**ADDENDUM NO. 1**  
**CSD-2025-012**

**TO:** **ALL RESPONDING PARTIES TO THE NOTICE INVITING BIDS FOR THE  
COUNCIL CHAMBER BUILDING ROOF REPLACEMENT PROJECT**

**SUBJECT:** **Responses to Questions and Clarifications**

### Frame Model 805SC

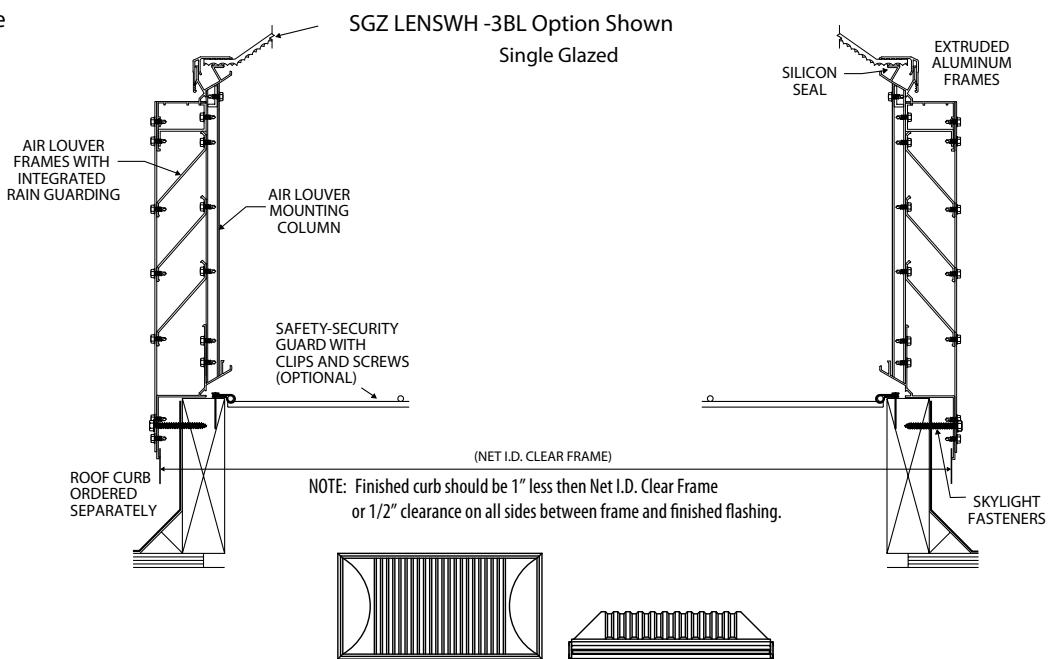
**15. What are the dimensions and the manufacturer of the desired skylights?**

The skylight dimensions are 42" X 42". Below is the link to the manufacturer specifications:

[https://www.aessunoptics.com/wp-content/uploads/2022/10/AES-Sunoptics-805sc\\_ss\\_cv-industrial-skylight.pdf](https://www.aessunoptics.com/wp-content/uploads/2022/10/AES-Sunoptics-805sc_ss_cv-industrial-skylight.pdf)

Model CLPOG

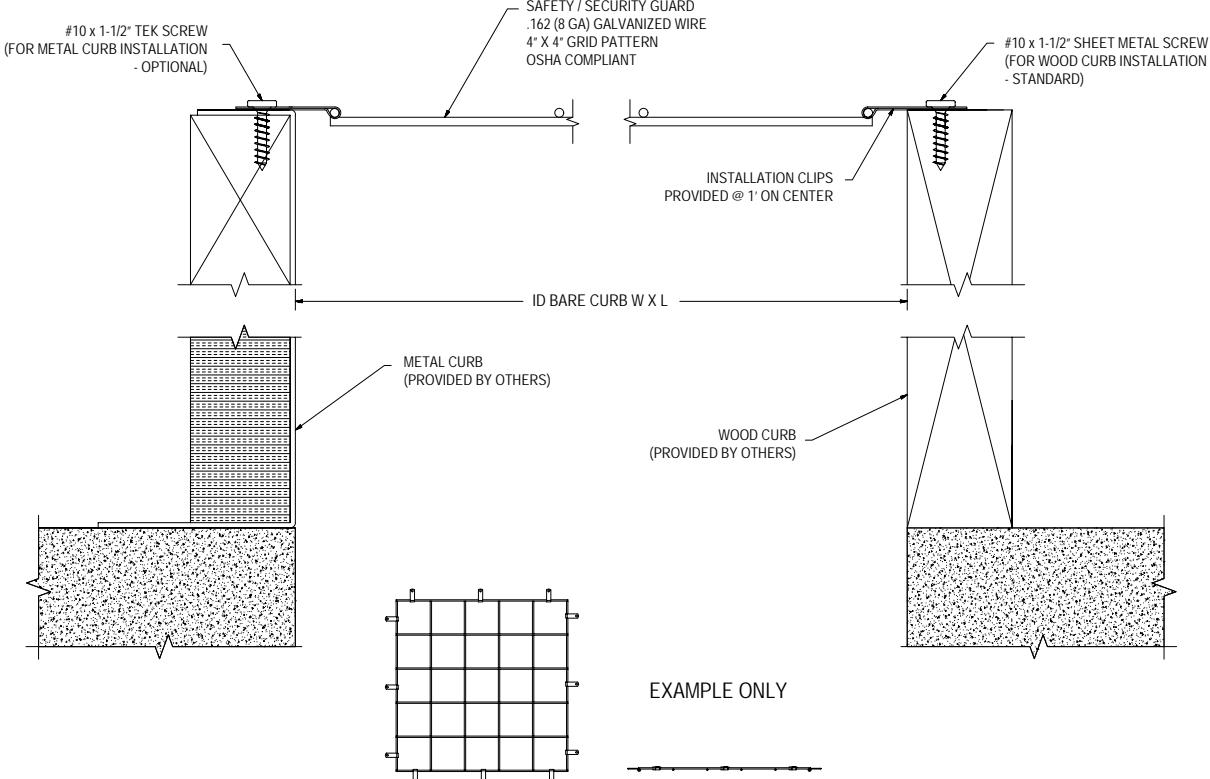
**Please see attached Revised Bid Schedule with line items for the two different hatch sizes identified and associated safety rail lines.**
- 6. Fall Protection at Skylights: Should we include fall protection for the skylights in our scope? If so, please specify the type (e.g. skylight screens, guardrails, etc.)**  
Yes, fall protection bars should be included for the skylights in the scope. The specifications for the fall protection are attached to this addendum, and below is the link to the specifications online:  
[https://www.sunoptics.com/wp-content/uploads/2022/10/SUNOPTICS-clip\\_on\\_fall\\_protection\\_data\\_sheet-04\\_2024.pdf](https://www.sunoptics.com/wp-content/uploads/2022/10/SUNOPTICS-clip_on_fall_protection_data_sheet-04_2024.pdf)
